### CIP P-10 STEWART PARK IMPROVEMENT PROJECT

## Addendum No. 1 RFB #CIP P-10 Stewart Park Improvement Project

### Questions and Answers

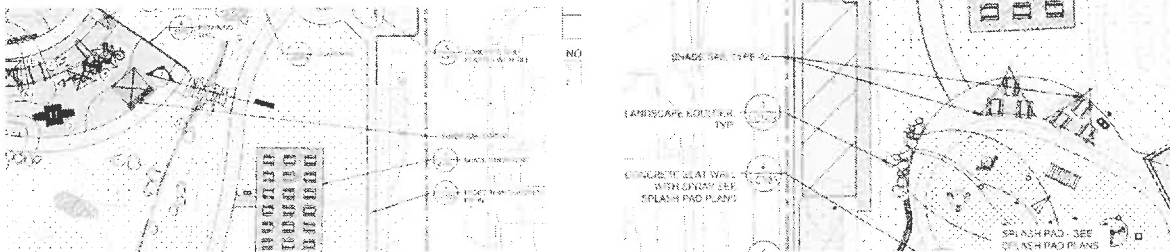
Q2. Where is the keynote 21 drinking fountain on sheet CD103 to be relocated to as it refers to the landscape plans but nothing is shown there?

A2. The drinking fountain should be removed and is not proposed to be relocated.
